GFA AD 534

GFA AIRWORTHINESS DIRECTIVE

Nimbus-3DT TYPE AFFECTED:

Amendments to Maintenance Manual SUBJECT:

2.4 Play in the wing attachment fittings

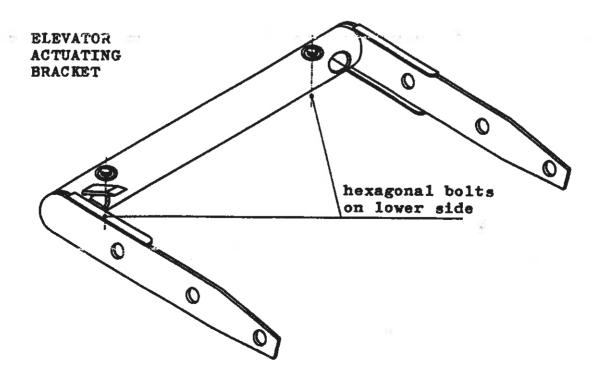
Tangential play (fore and aft movement) can occur through wear in the shims on the wing locating pins.

If the wing tips are free to move more than 30 mm (1.18 in.) or if play of the tip extensions is observed, further shims of a thickness of between 0.3 and 0.5 mm (0.01 to 0.02 in.) with an internal diameter of

- 17.95 mm (0.71 in.) for the inbd. wing panels.
- 13.95 mm (0.55 in.) for the outbd. wing panels and
 - 9.95 mm (0.39 in.) for the tip extensions

should be added progressively up to the point where the panels (or tip extensions) rig well, but the play has been eliminated.
